Re: **Response to NOIA Application ID: 2-6105-00889/00001**

Sharps Compliance, Inc. (“Sharps”), is providing the following information requested in your October 12, 2018 email regarding Sharps’ proposed Transfer Station (Project) requesting to address the following comments:

**ADDENDUM TO
SHARPS COMPLIANCE, INC.
ENGINEERING REPORT FOR REGULATED MEDICAL
WASTE TRANSFER STATION
(REVISED OCTOBER 22, 2018)**

SITE PLAN TRANSFER STATION
 SHARPS COMPLIANCE, INC.
 803 SHEPHERD AVENUE
 BROOKLYN, NEW YORK 11208

DRAWING C-01 – SITE PLAN

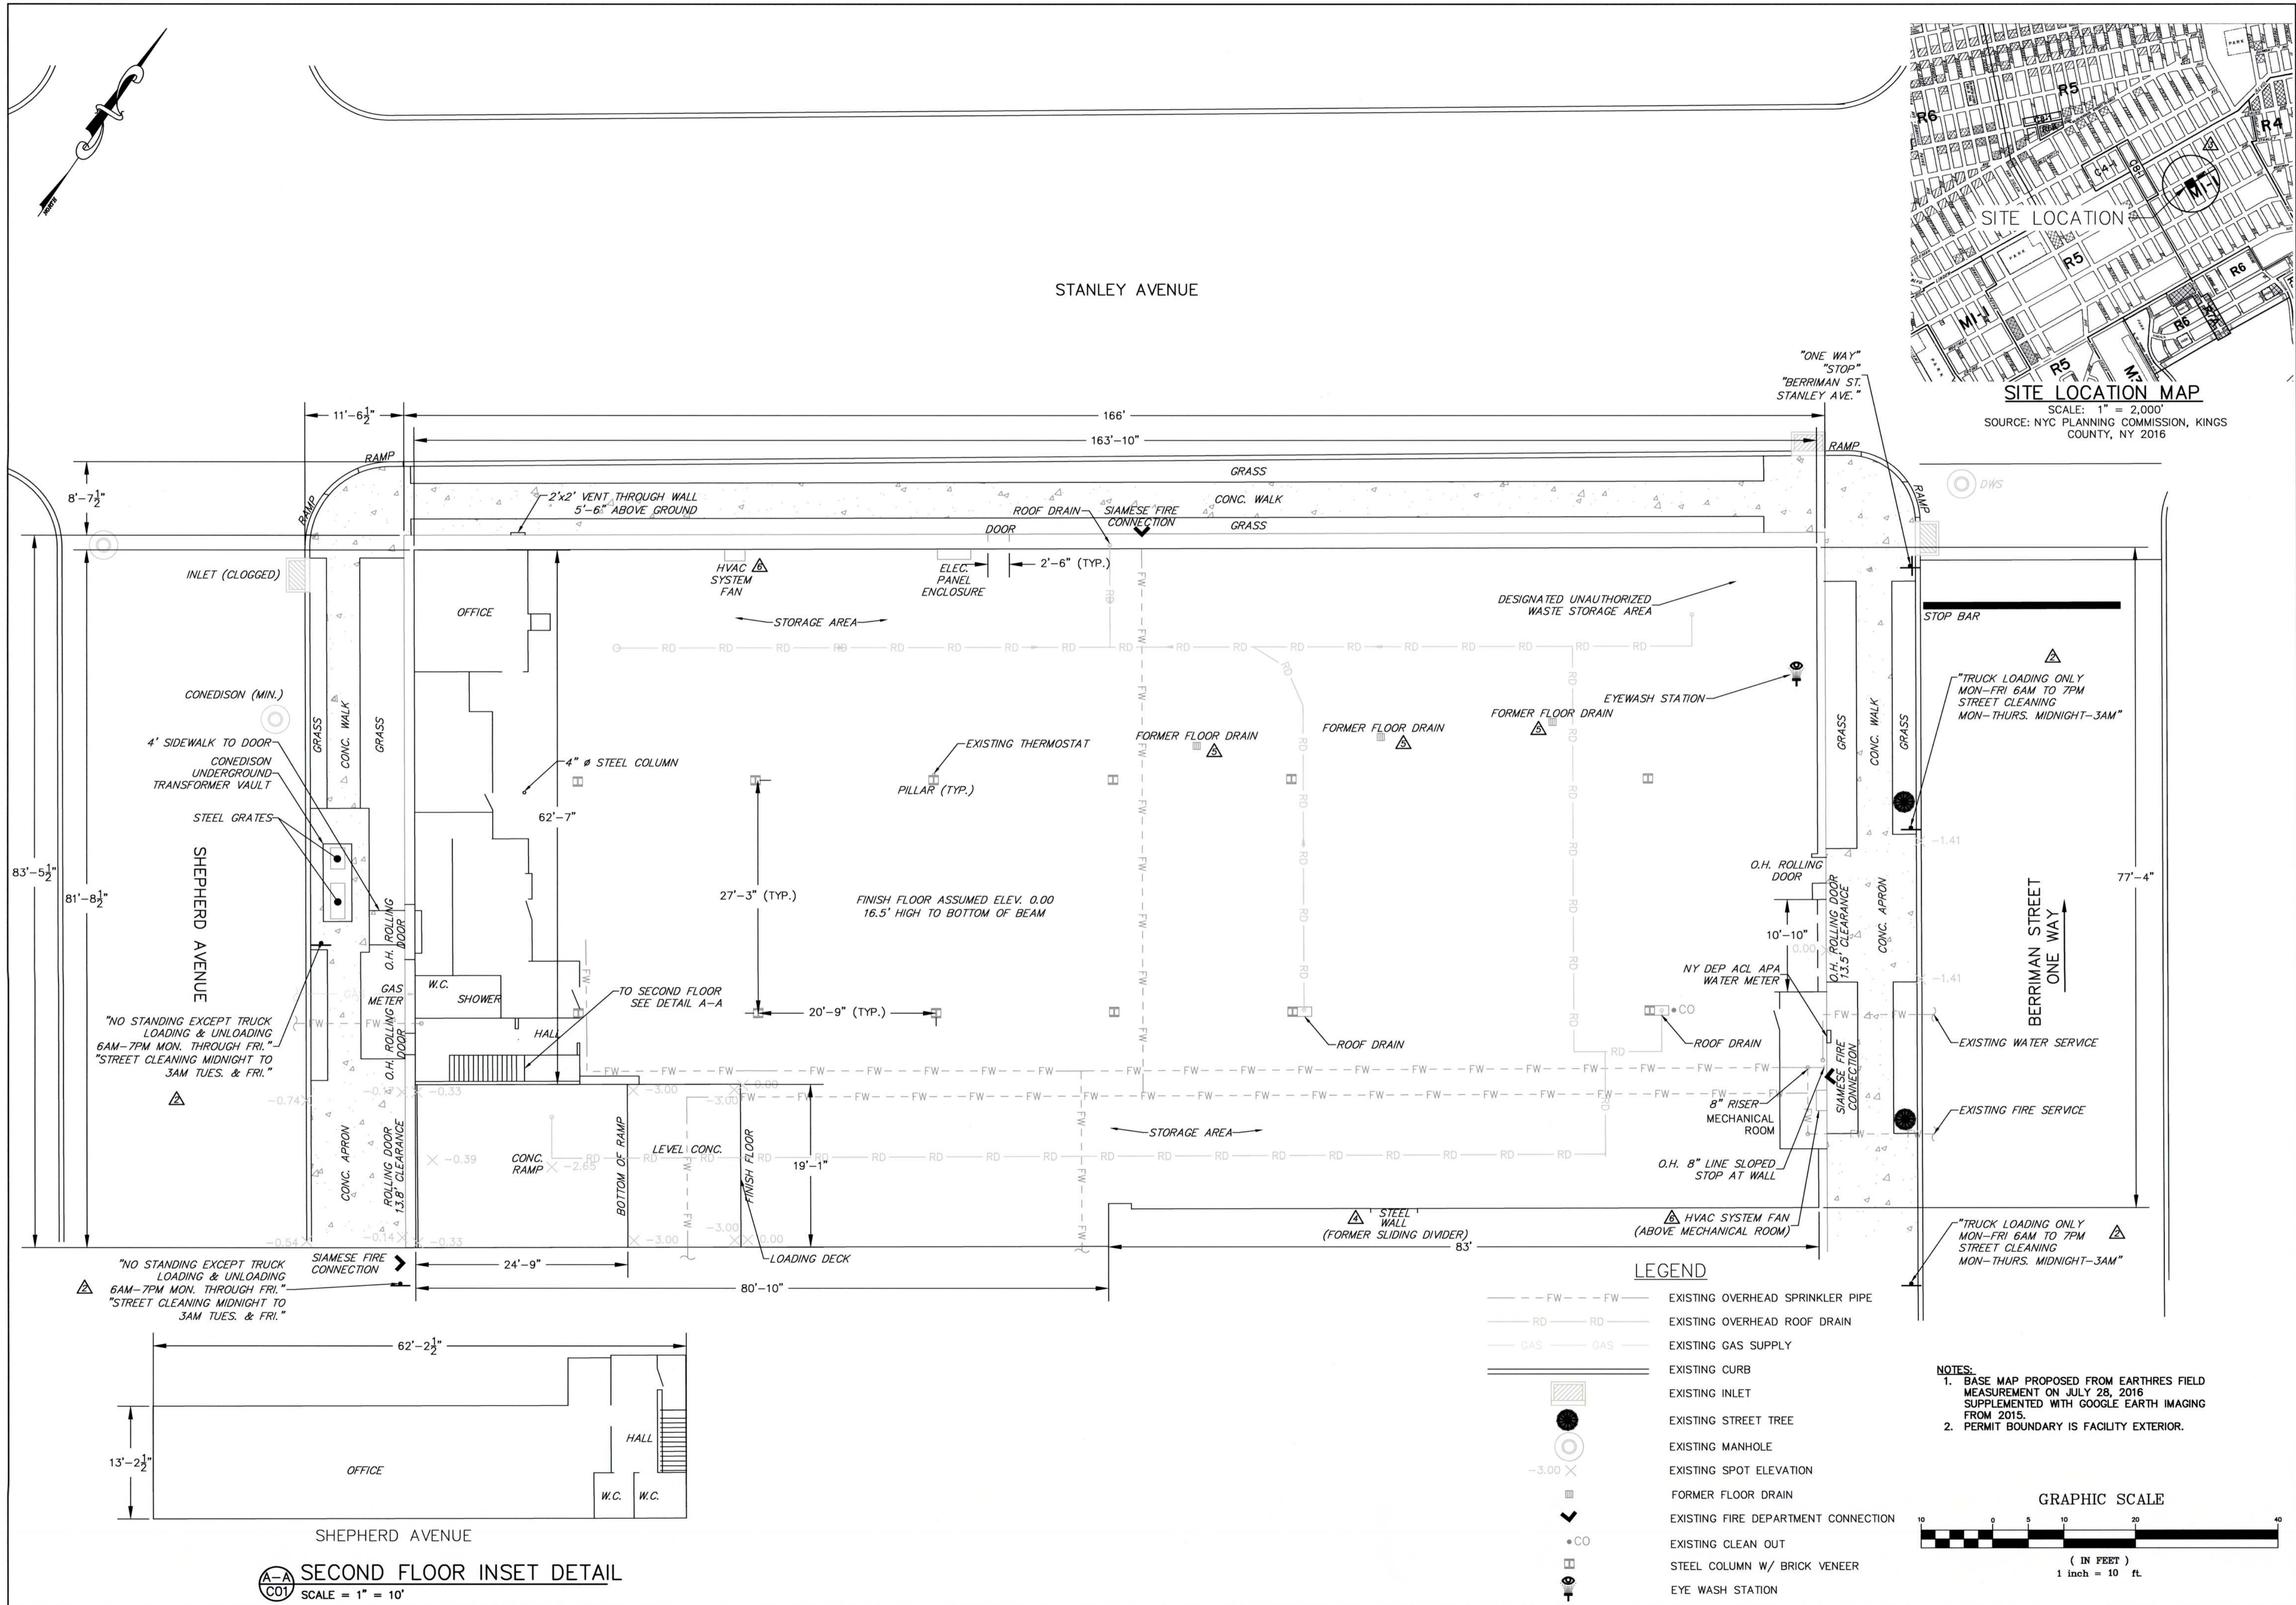
1. *The materials management unit has recently been made aware that the proposed Sharps Compliance location has installed a “Modified HVAC System”. This modification needs to be identified and incorporated into the application that is currently under review. Therefore, please provide the following information:*
 - a. *A figure that identifies the location of the HVAC System;*
 - b. *Manufacture specifications for the HVAC System; and*
 - c. *Maintenance schedule for the HVAC System*

Sharps Response: The proposed Sharps Transfer Station has installed a modified HVAC system consisting of two (2) fans (one (1) CANARM HVAC Model No. AX30-2 and one (1) LFI Axial Fans Model No. P20-1RS9M115). Drawing No. C-01 has been revised to show the locations of the modified HVAC system fans (see Attachment G). Manufacturer’s literature including a maintenance program are provided in Attachment H of this Addendum to the June 19, 2018 revised Engineering Report. The tasks listed in the maintenance program (periodic cleaning; check and tighten all nuts, bolts, set screws; and, check for damage or worn parts (signs of corrosion) and refinish/replace) will be conducted on a monthly basis to ensure proper operation and efficiency of the HVAC system. A statement from Sharps indicating that the newly installed HVAC system will be operated at all times during facility operations and maintained per manufacturer’s specifications/maintenance program is also provided in Attachment H. A revised Table of Contents identifying each attachment with a summary description of the contents has been included in the addendum binder (see attached). These revisions / additions to the Addendum to the June 19, 2018 revised Engineering Report are reflected in the Table of Contents.

NO.	DATE	BY	REVISIONS
10/22/18	SP		ADDED HVAC SYSTEM FAN LOCATIONS
6/19/18	SP		REVISED FORMER FLOOR DRAIN LABELING
5/1/18	SP		REVISED SLIDING DOOR LABELING
2/5/18	SP		ADDED 800' PERIMETER (360.16(G)(2))
2/5/18	SP		REVISED OPERATING HOURS
9/12/17	JUB		REVISED PER NYSDEC COMMENTS
